SUBJECT: MEETING NOTIFICATION AND TRANSMITTAL OF AGENDA

MEETING MINUTES FROM THE
MARICOPA ASSOCIATION OF GOVERNMENTS
STANDARD SPECIFICATIONS AND DETAILS COMMITTEE

2010 PROPOSED REVISIONS TO MAG SPECIFICATIONS AND DETAILS

TYPICAL SECTION AND TRENCH ALIGNMENT

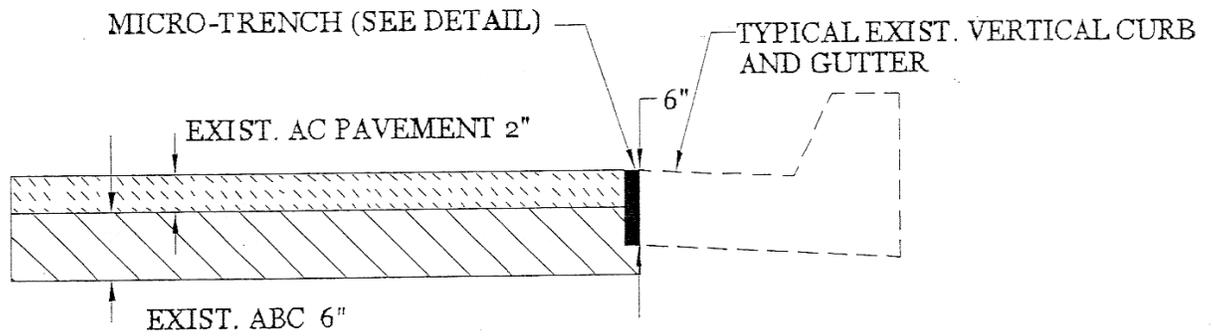
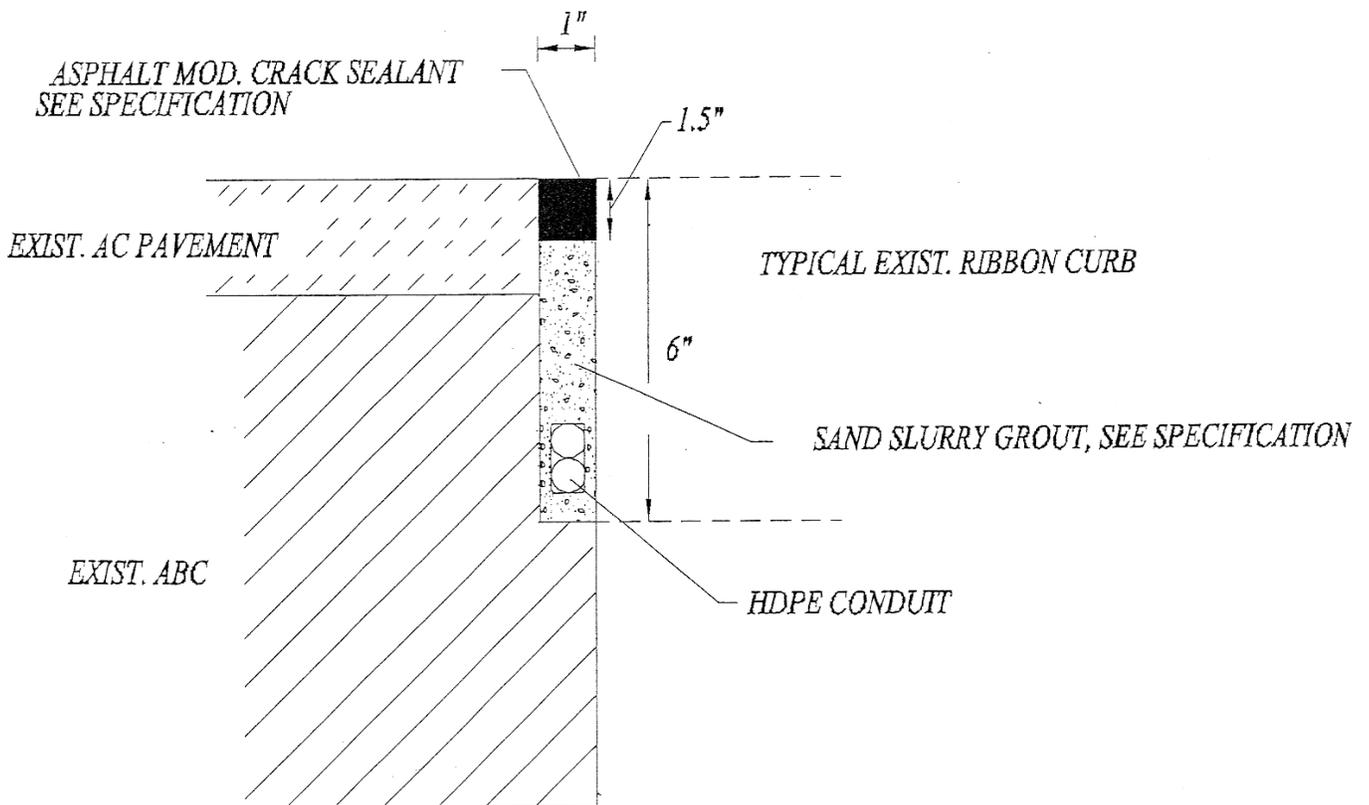
361.3 MICRO-CONDUIT INSTALLATION:

(A) "Trunk Lines" Cable providing telecommunications service by connecting regions or states or by connecting central offices within a metropolitan area. Such cable shall be installed as described below:

(B) Telecommunications cables other than "trunk lines" shall be installed as described below:
